City of Portland, Maine – Building or Use Permit Application 389 Congress Street, 04101, Tel: (207) 874-8703, FAX: 874-8716

BUILDING PERMIT REPORT

REASON FOR PERMIT: To construct a single family dwelling attached private garage

**CITY OF PORTLAND, ME
BOCA 1999 Plan Review Record
One and Two Family Dwelling**

PLOT PLAN
OF:
LOT 18 AUBURN PINES SUBDIVISION
ALICE COURT
PORTLAND, ME
FOR:
JOSEPH PAOLINO
P.O BOX 2024
WINDHAM, ME 04062

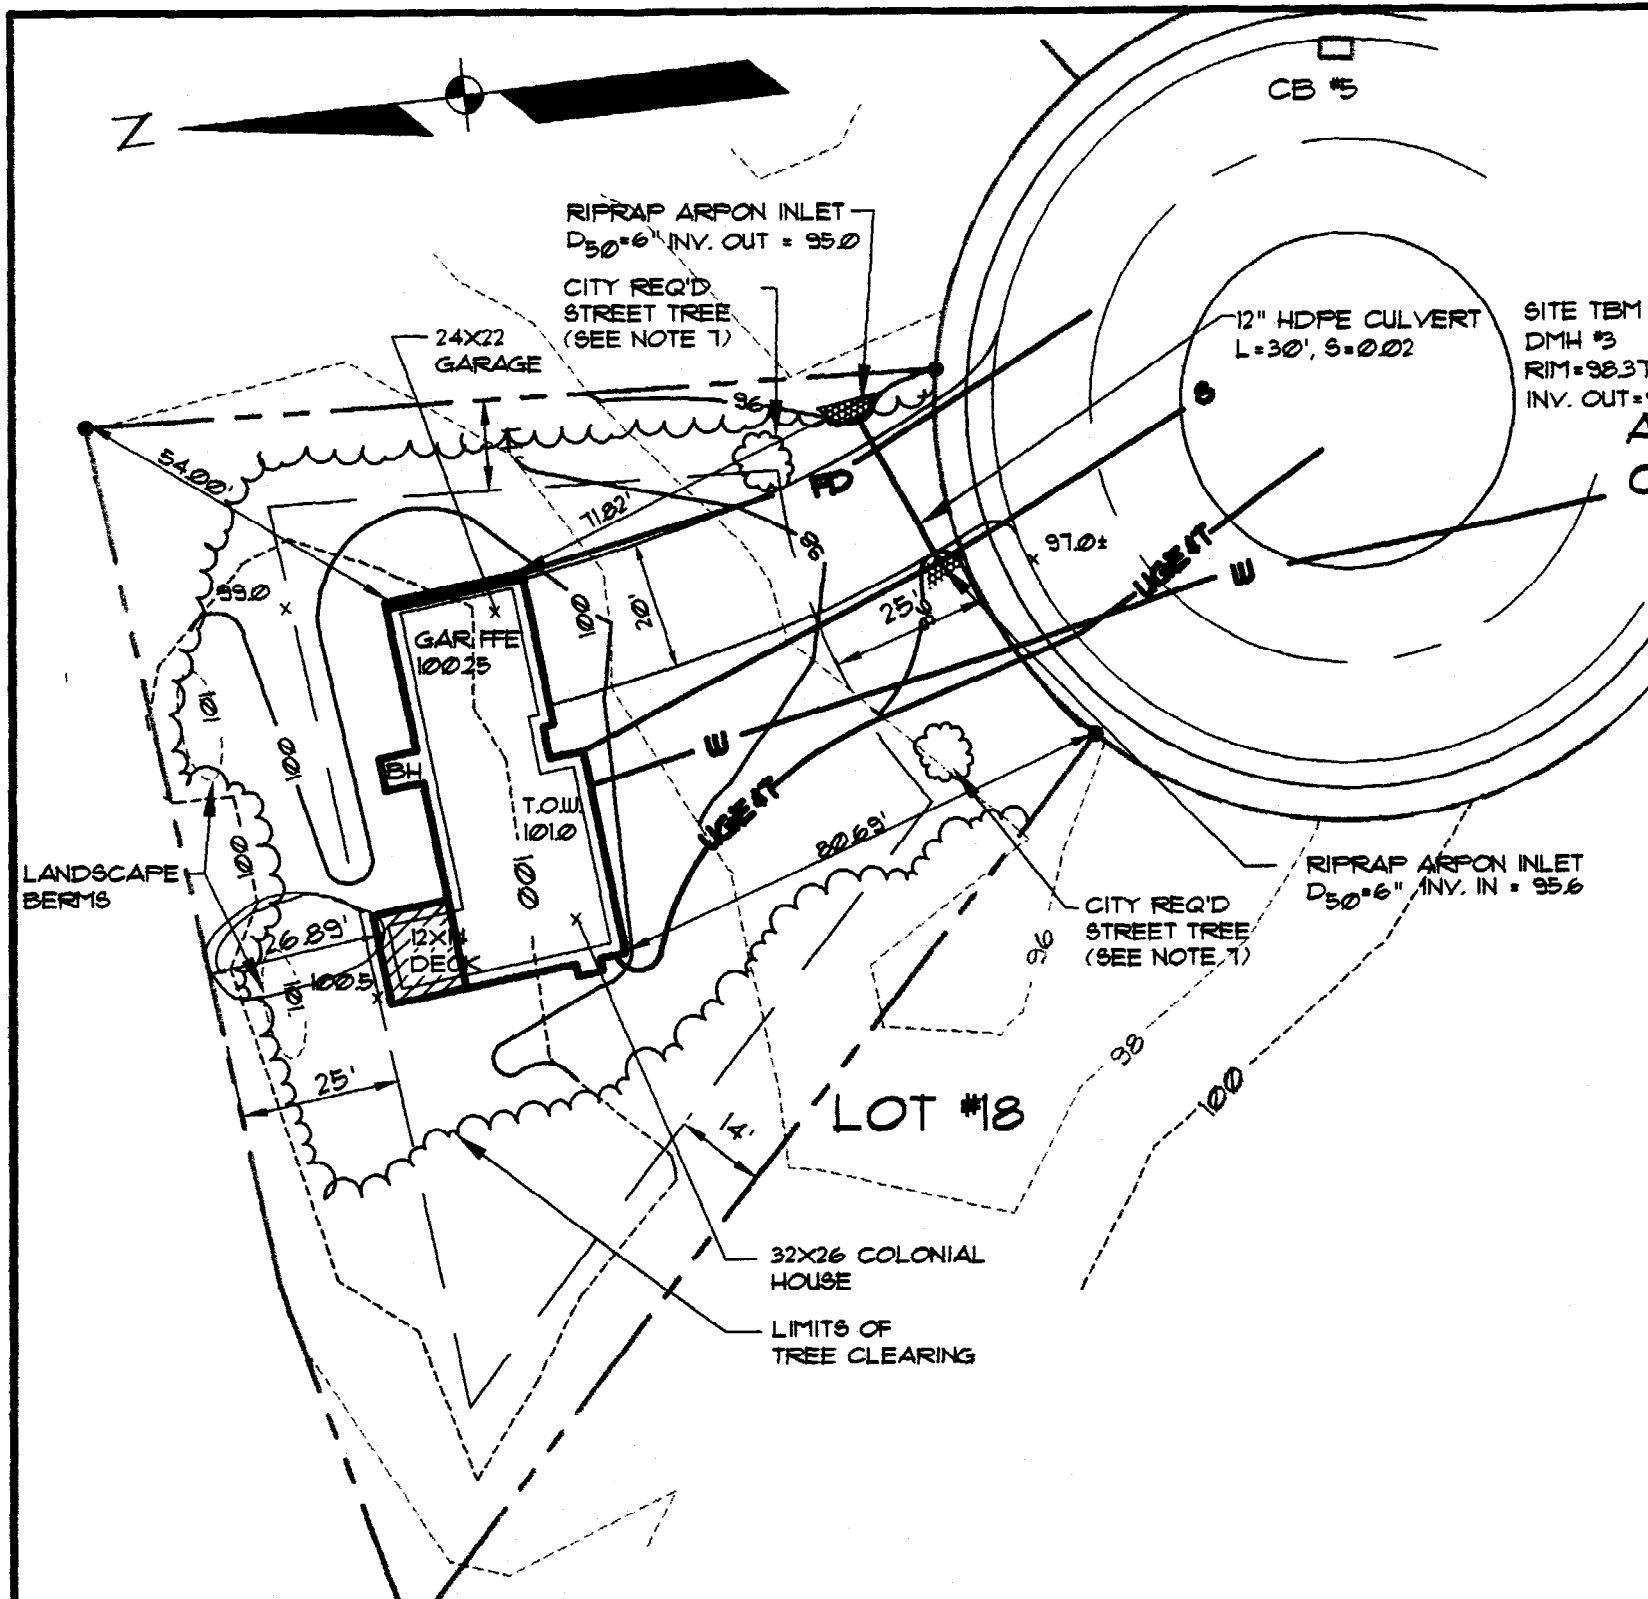
Show all utility connections: water, sanitary, sewer, storm drain, electric, telephone, cable.

A drainage plan shall be submitted to and approved by Development Review Coordinator showing first floor elevation (FFE), sill elevation (SE), finish street/curb elevation, lot grading, existing and proposed contours, drainage patterns and paths, drainage swales, grades at or near abutting property lines, erosion control devices and locations and outlets for drainage from the property.

Applicant shall take care to assure that this lot does not drain onto either lot #17 or #19.
